**CAPISTRANO UNIFIED SCHOOL DISTRICT**

**NEWHART MIDDLE SCHOOL**  
**300 BLDG RE-ROOF PROJECT**

03/23/2023 Pre-Bid Addendum #1

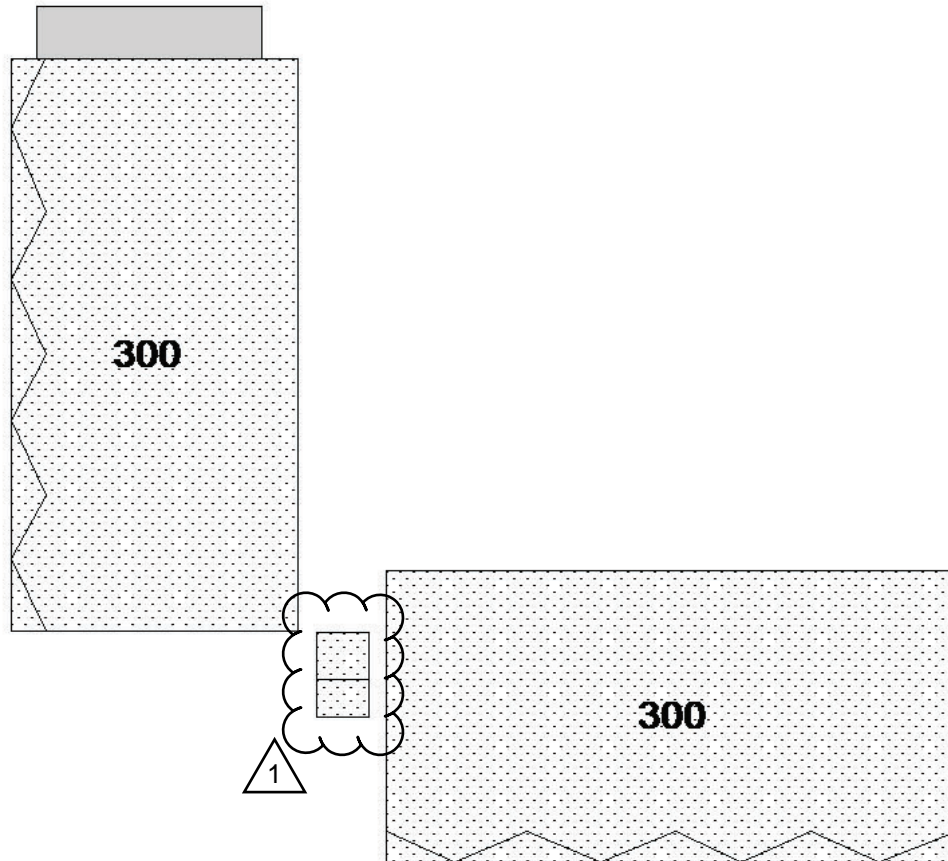
**Notes - Replace main and overflow scuppers**  
**Install new clad metal integrated coping system**  
**Re-use existing downspouts**  
**Install new crickets between drain points**  
**Add emergency letter at locations indicated matching existing size**  
**Include replacing 20 sheets of 4' x 8' plywood matching existing**

NOT IN SCOPE
